**CORTE MADERA PLANNING COMMISSION  
STAFF REPORT**

**ITEM NO. 5A**                      **REPORT DATE:**                      **April 22, 2010**  
**MEETING DATE:**                      **April 27, 2010**

**SUBJECT:**                      **DESIGN REVIEW APPLICATION NO. 10-005** - To approve an exterior remodel of a commercial space at Corte Madera Town Center with a new storefront, new exterior materials, new sign program, enclosure of the mall-side pedestrian breezeway and parking lot/ landscape modifications.

**LOCATION:**                      332 Corte Madera Town Center (Urban Outfitters)

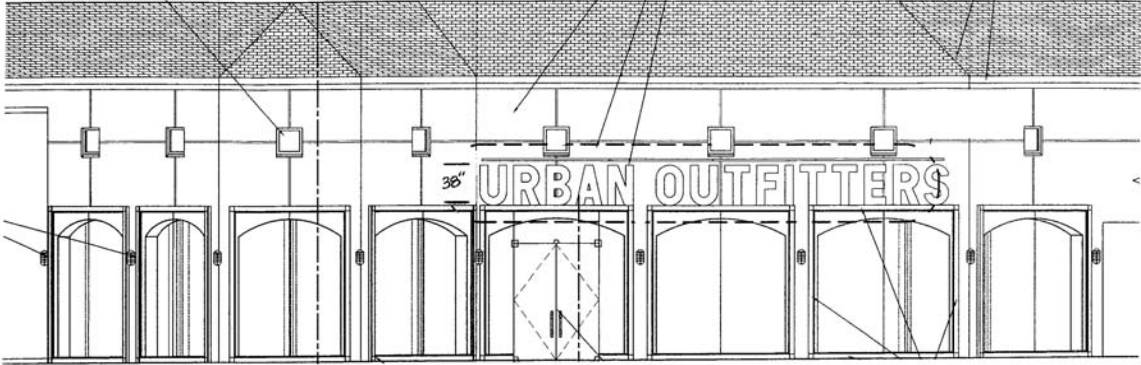
The Corte Madera Town Center Design Guidelines regulate signs. Individual illuminated letters are encouraged. Roof signs and signage extending above the building parapet are prohibited. The size of a sign is calculated by measuring the simplest geometric shape around the sign text. Although, if the sign is attached to background structure which is not integral to the building design and building materials, the background structure is also considered sign area. Staff believes

the entire metal mesh framing used for the parking lot sign must be counted toward sign area since the rectangular mesh structure is clearly dissimilar to the building materials.

The proposed Urban Outfitters signs on both the parking lot side and the mall side are larger than all other signs in the survey. Staff believes the Urban Outfitters sign program is oversized and out of proportion with the storefronts. Staff recommends that the parking lot sign be limited to the easterly raised parapet (where URBAN is located). Pier 1 Import's current sign is located here and is adequately visible. The metal mesh framing (where OUTFITTERS is located) also protrudes above the storefront parapet which is not allowed by the Design Guidelines or the town's Sign Ordinance. In addition, the OUTFITTERS sign would be partially blocked by a mature tree, which makes this sign less necessary.

Staff recommends that the mall side sign be proportionally reduced by approximately 30% to be more proportional to the storefront. The proposed letters are 38" in height and span 36'-7". Such a large sign is completely unnecessary for this interior courtyard location. It would seem more appropriate for a storefront facing a wide, busy thoroughfare. An accurate drawing of the proposed sign is shown below. The curved storefront is shown as straight façade. The signage on the color rendering of the mall side storefront shown on page 2 of this report is not drawn to scale. The signs were drawn too small.

*DESIGN REVIEW FOR THE PARKING LOT*

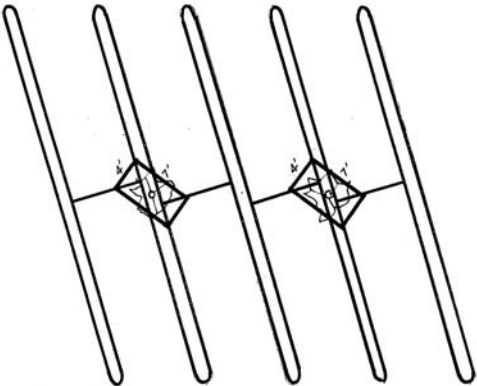
In order to gain four parking spaces in the parking lot due to the 876 sq.ft. breezeway enclosure, two large landscape islands within the parking lot (each with two trees) will be removed and converted to four parking spaces. Four small landscape islands (each with one tree) will be added to the parking lot to replace the four trees removed. These small islands do not affect parking spaces because they are oriented between head-on angled parking spaces. (see an example below of small landscape islands with one tree).

Alternatively, replacement landscape islands with a total of four trees can be developed at the end of drive isles within the parking lot if adequate drive isle widths remain.
